SUBJ: Change Order #6 for Boundary Street Redevelopment Construction

Change Order 6 (CO 6) is for adjustments in the duct bank construction details, variances in structure locations and alignment. CO 6 has been reviewed by the project Construction Manager and was recommended for approval. The City of Beaufort Manager and the County Administrator have signed the change order for acceptance and City Council approved CO 6 on November 8, 2016. Therefore, it is requested that CO 6 be approved by the Committee so it can be included on the contractor's purchase order and processed for payment.

Rpt-ID: RCOCORPT	Date: 10/28/2016								
User: frailxja	Department of Transportation								
	Change	Order Report							
Contract ID: LPA07.036939A Change Order Nbr: 006 Force Acct ID: 0 Change Order Type: Standard Change Order CO Description: Boundary Street Right Side Duct Bank Impacts Zero Dollar Change Order: No						47			
Project NbrItm NbrCatgItem Code0036939RD01202119800100Item DescriptionCHANGE ORDER ITEMSupplemental Description1Boundary Street Right Side Duct Bank isSupplemental Description2	Unit Unit Price LS \$83,860.63 CO Item Description	Bid Qty 0 n Boundary S	Prev Apprvd Qty 0 Stree

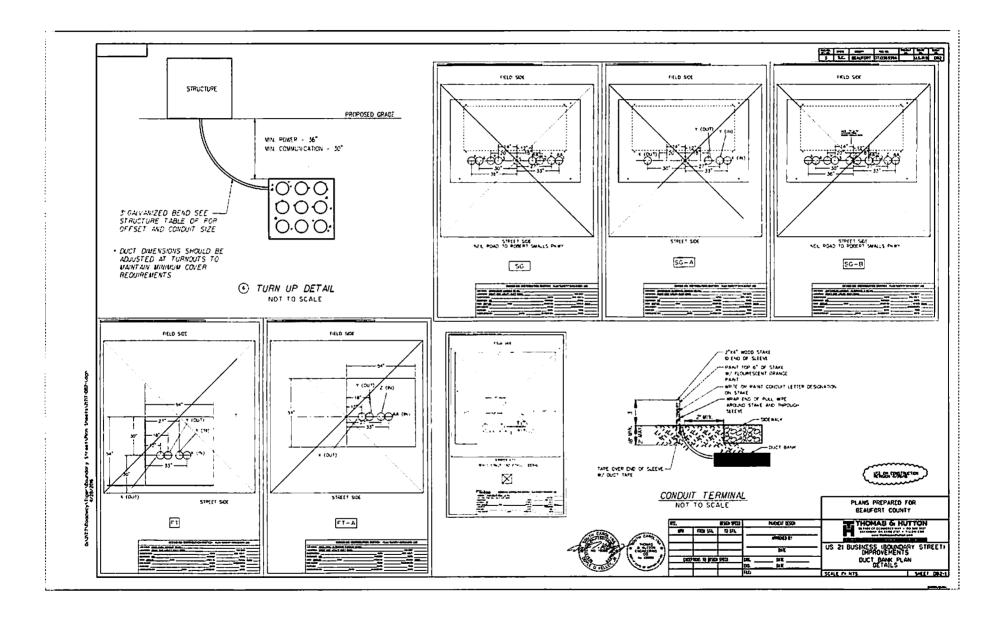
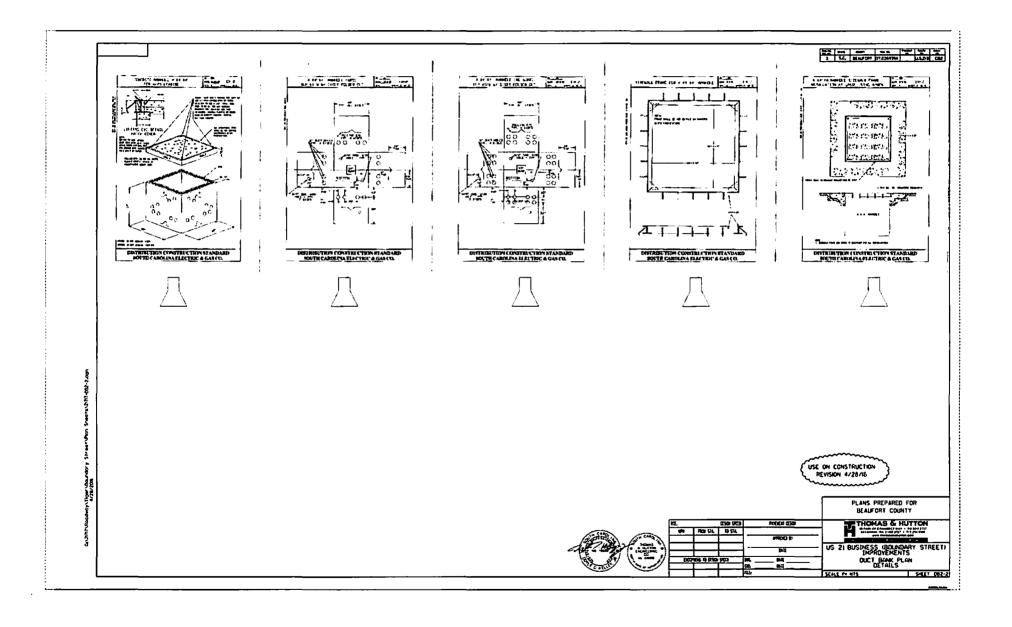
While the modification of details 3&4 reduced the amount of flowable fill on the project, it caused the construction activities to consume additional time and resources. At the commencement of the duct bank construction, SCE&G requested the bottom ducts be encased in flowable fill separate from the top communication ducts. This change added concrete cure time before the top communication ducts could be installed, backfilled, and completed. PMI anticipated an average production of 100LF per day to install details 3 &4. This change doubled the amount of construction time necessary to complete said details. The daily reports for the project will show that the 100LF per day was achievable had the design changes been clarified prior to constructing the duct bank. 2361LF of duct bank was installed on the Right side of construction centerline. It took PMI approximately 47 days to install 2361LF of duct bank resulting in an additional 23 days.

- 2. The revised equipment locations and duct configuration greatly complicated the construction of each turn out location both from a constructability and project duration perspective. Each individualized configuration caused several additional bends in an extremely crowded work area, utilizing much more time, materials and resources to perform this work. PMI assumed two turn out locations per day to complete based off the original configuration (attached). With the revised 14 structures, it took PMI an additional 15 days to complete the 14 locations. To complicate matters Structures 16 and 17 had easement procurement and utility conflicts respectfully that caused PMI to re-mobilize to finish once those issues were resolved.

- 3. The reduction in quantity on the right side has skewed the average level of effort on the project. Deleting less significant (less ducts / less complicated) work has caused the average pricing of the single duct bank line item on the project to increase in an effort to maintain the overall project average. PMI had to assume all duct configurations into a single per linear foot price as there is one pay item to cover all duct bank details. The following table depicts our subcontractors approach to each duct bank detail:

4. Lastly, the lack of a specific and constructible location (horizontal and vertical) of the right side duct bank predicated several field meetings, additional field layout, and survey effort to determine an adequate corridor to facilitate the duct bank construction. This was not anticipated at the time of our bid and has increased the overall survey time and effort on the project.

We have reviewed both the original baseline CPM schedule and the actual in-place work performed to construct the right side duct bank. Based on the original activity #A1060 (Ductbank – Boundary Street Right), you had anticipated to install 50.2lf of duct bank per work day (assuming the first 15 days of the 86 day duration were used for survey, exploratory excavations, material procurement and site preparations). Using this rate to install the 2,710lf of duct bank built in place, it should have taken 48 days to install the complete right side section. However, due to the impacts to the contractor as listed above, the actual duration of this same section took 83 work days. That is an increase of 35 work days. Due to some inefficiencies that are recognized by both parties, 5 days (approximately 5% of the 83 days) are being deducted from the 35 days beyond planned performance to provide a final time extension of 30 work days (42 calendar days).

The cost portion of the adjustment was also reviewed. The cost impact is directly related to the additional time spent constructing the duct bank, along with the added effort and material to turn the ductbank up at the structure locations. The equitable adjustment will be comprised of the following (details attached):

Additional daily labor cost of \$2,669.00 for 30 days	\$ 80,070.00
Additional mobilization cost of \$1,500.00 for 2 occurrences	\$ 3,000.00
Additional survey required for changes to alignment	\$ 7,500.00
Reduction of concrete for communication conduits	\$ (20,738.73)
Additional cost of materials for connection to structures	\$ 14,029.36
	\$ 83,860.63

Further review of impacts to the loaded unit rate will be determined when final details for SCE&G structures are provided and modifications to ductbank details are determined to complete the left side ductbank. The total value for this change order is a time extension of 42 calendar days and an equitable adjustment of \$ 83,860.63.

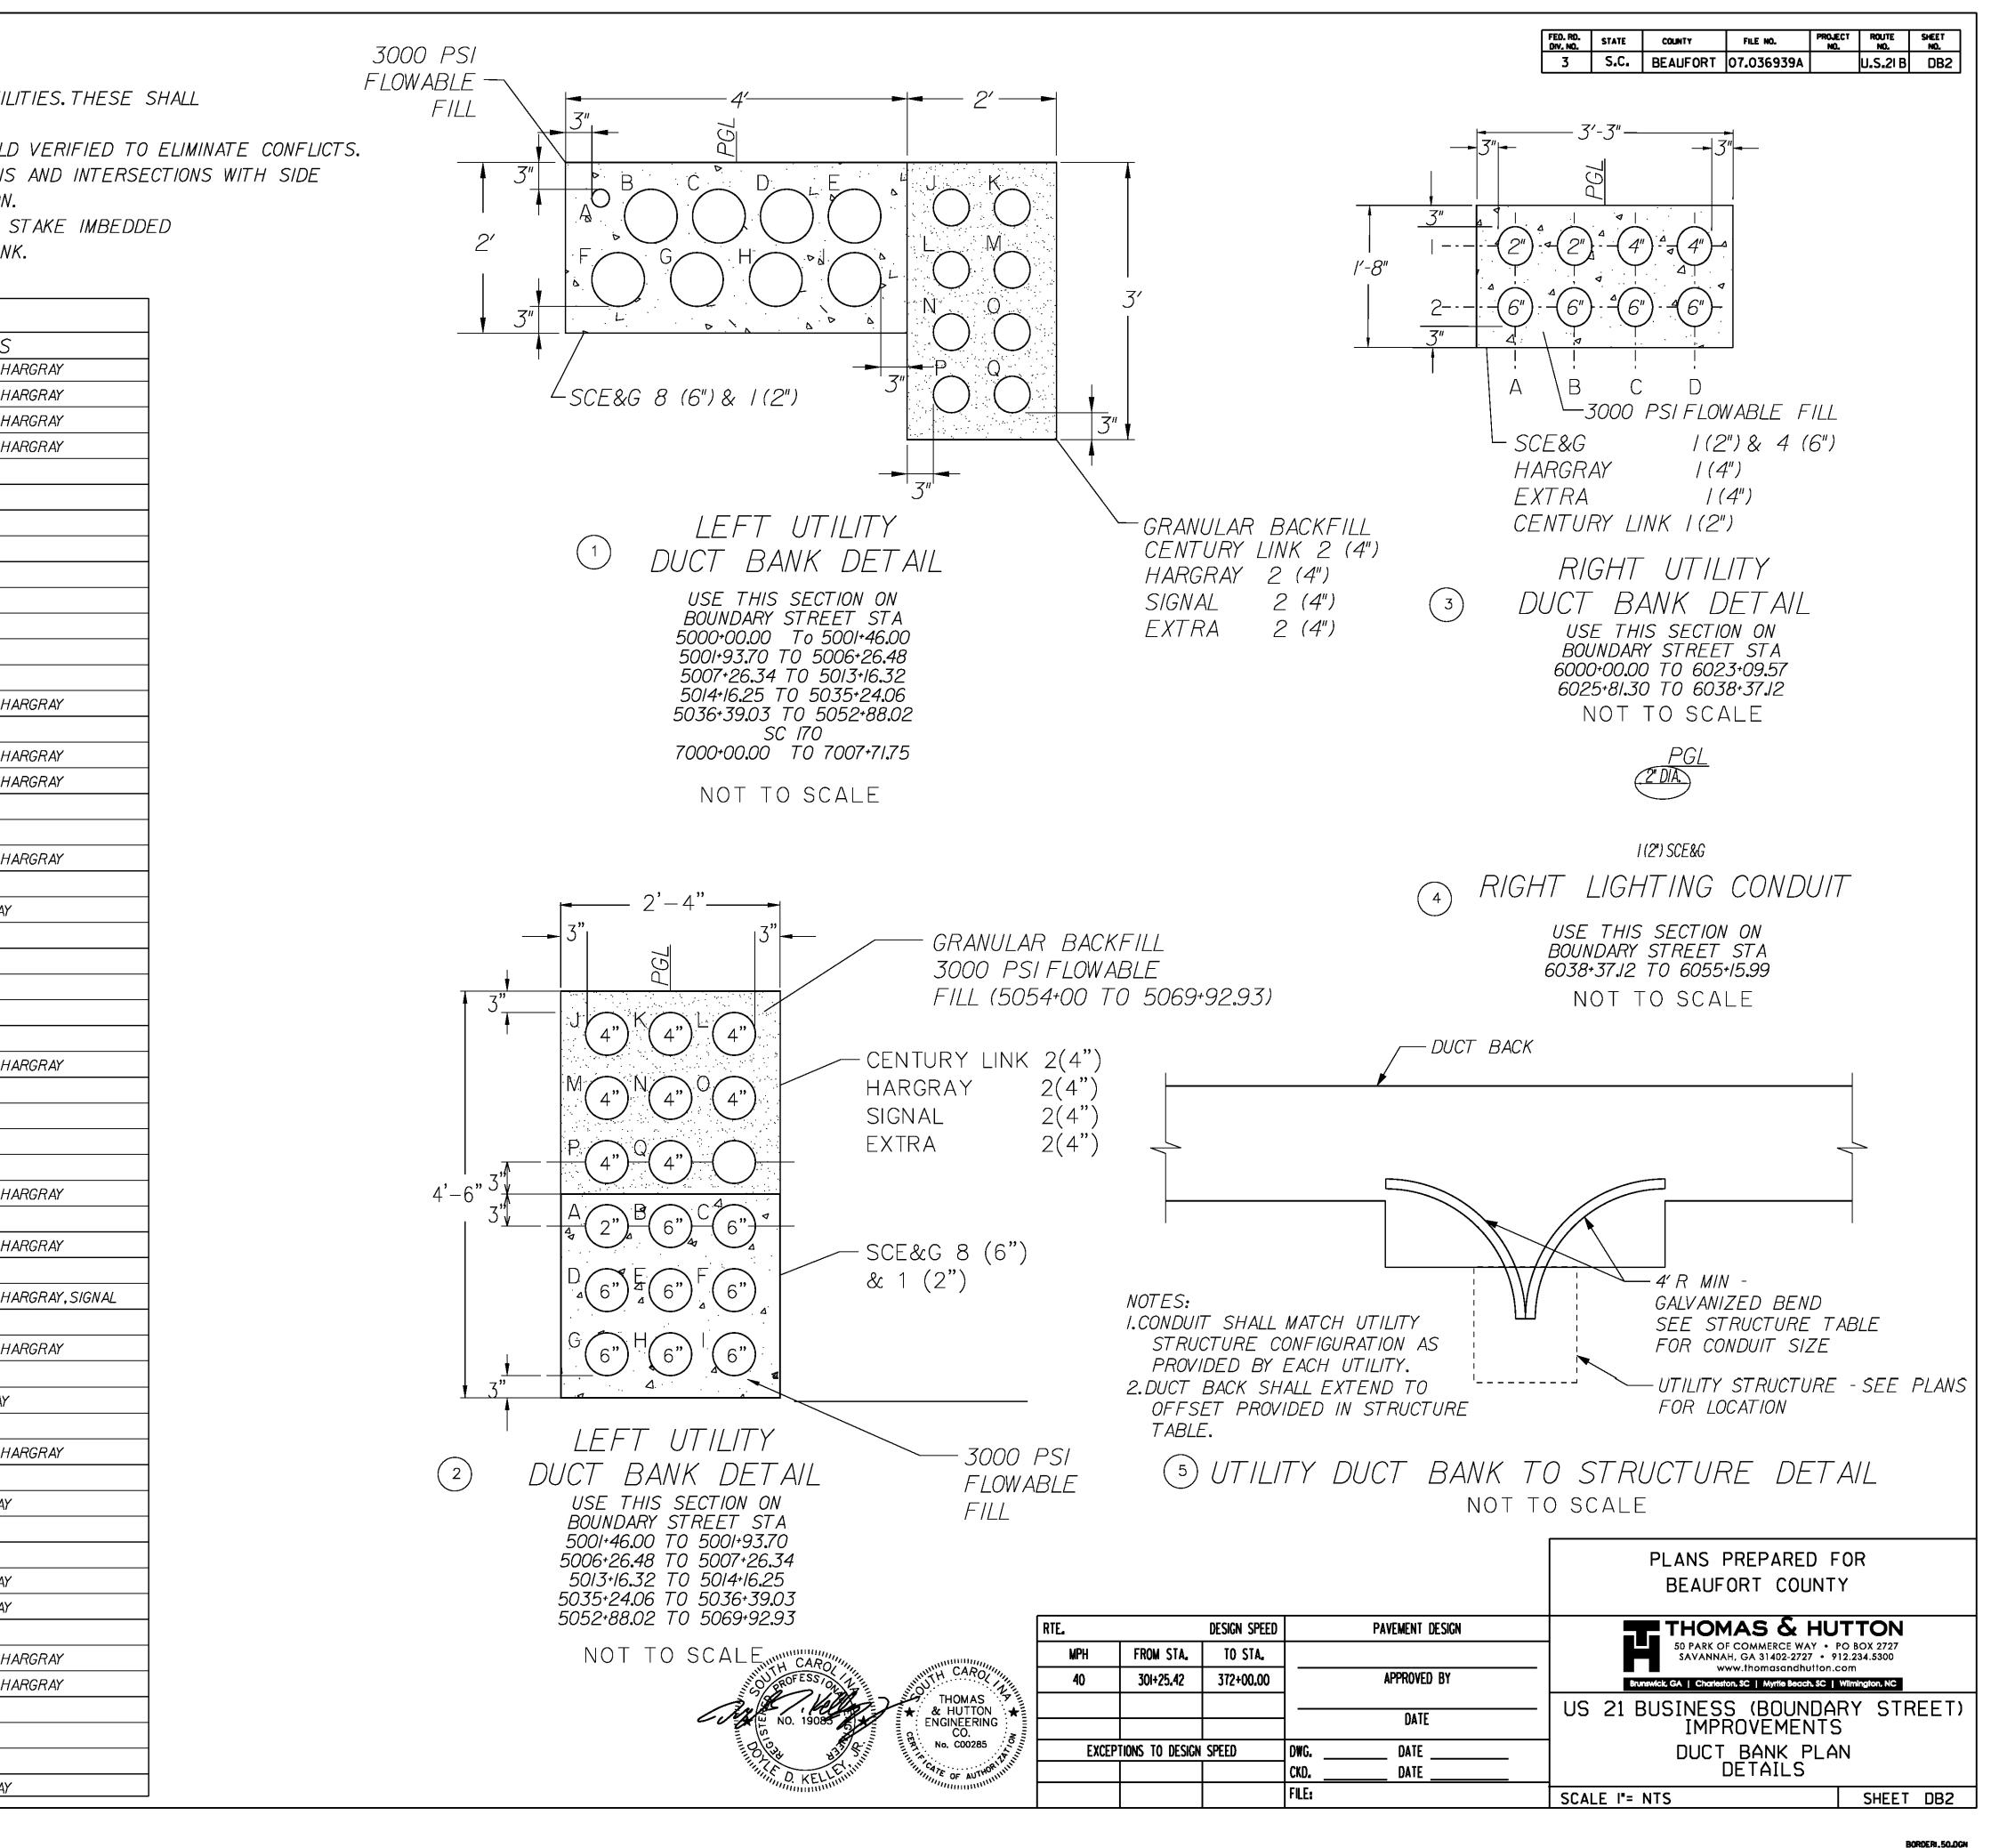
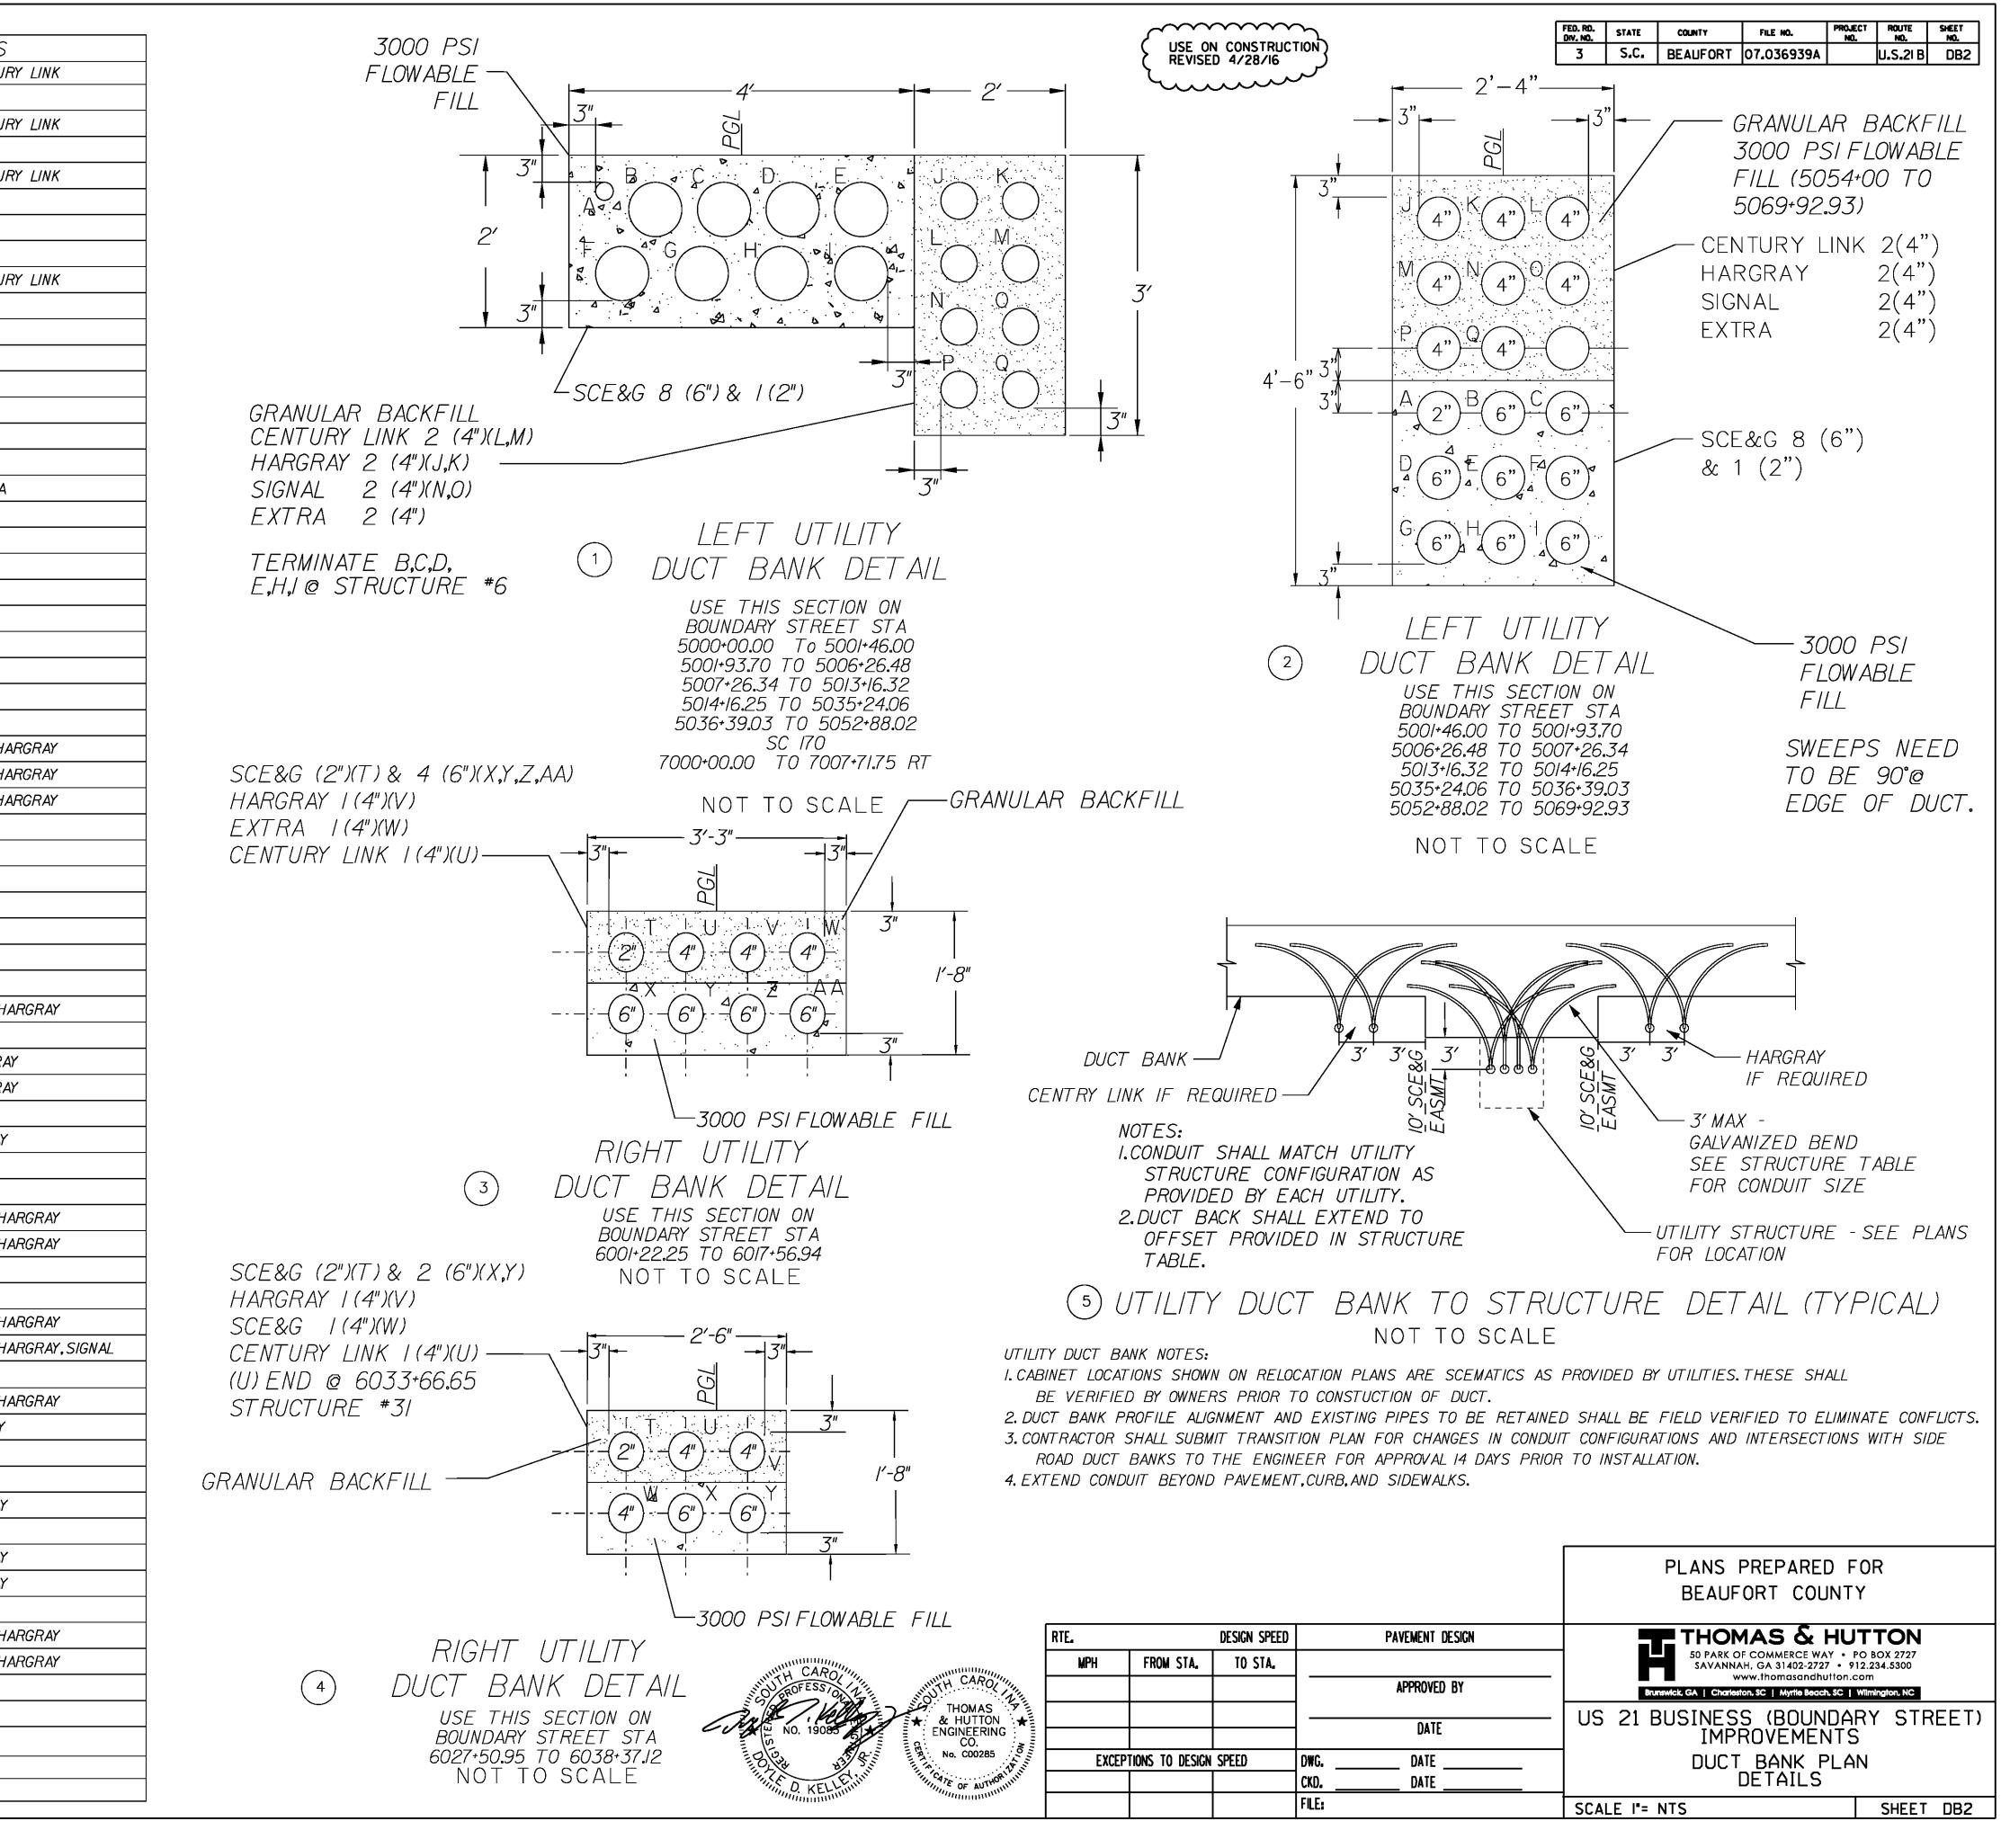
While the modification of details 3&4 reduced the amount of flowable fill on the project, it caused the construction activities to consume additional time and resources. At the commencement of the duct bank construction, SCE&G requested the bottom ducts be encased in flowable fill separate from the top communication ducts. This change added concrete cure time before the top communication ducts could be installed, backfilled, and completed. PMI anticipated an average production of 100LF per day to install details 3 &4. This change doubled the amount of construction time necessary to complete said details. The daily reports for the project will show that the 100LF per day was achievable had the design changes been clarified prior to constructing the duct bank. 2361LF of duct bank was installed on the Right side of construction centerline. It took PMI approximately 47 days to install 2361LF of duct bank resulting in an additional 23 days.

- 2. The revised equipment locations and duct configuration greatly complicated the construction of each turn out location both from a constructability and project duration perspective. Each individualized configuration caused several additional bends in an extremely crowded work area, utilizing much more time, materials and resources to perform this work. PMI assumed two turn out locations per day to complete based off the original configuration (attached). With the revised 14 structures, it took PMI an additional 15 days to complete the 14 locations. To complicate matters Structures 16 and 17 had easement procurement and utility conflicts respectfully that caused PMI to re-mobilize to finish once those issues were resolved.

- 3. The reduction in quantity on the right side has skewed the average level of effort on the project. Deleting less significant (less ducts / less complicated) work has caused the average pricing of the single duct bank line item on the project to increase in an effort to maintain the overall project average. PMI had to assume all duct configurations into a single per linear foot price as there is one pay item to cover all duct bank details. The following table depicts our subcontractors approach to each duct bank detail:

Impact	Description	Quantity	Unit	Unit Price	Total	Comment
#1 & #2	Additional Time per linear foot installed		Days			
	Additional Time per turn out location		Days			
					30	Working Days and/or 42 Calendar Days
	Additional Mobilization to structures 16 and 17	2	EA	\$1,500.00	\$3,000.00	
	Additional Daily Cost Associated with Duct Configuration		Days	\$2,669.00	\$0.00	
	Additional Daily Cost Associated with Structure Changes		Days	\$2,669.00	\$0.00	
		30	Days	\$2,669.00	\$80,070.00

#3	Detail 3 Changes					
	Length Changes	0	LF	\$64.61	\$0.00	adjust contract unit price later
	Concrete Reduction	121.6524	CY	\$113.95	-\$13,862.29	
	Detail 4 Changes					
	Length Changes	0	LF	\$73.85	\$0.00	
	Concrete Reduction	60.34614	СҮ	\$113.95	-\$6,876.44
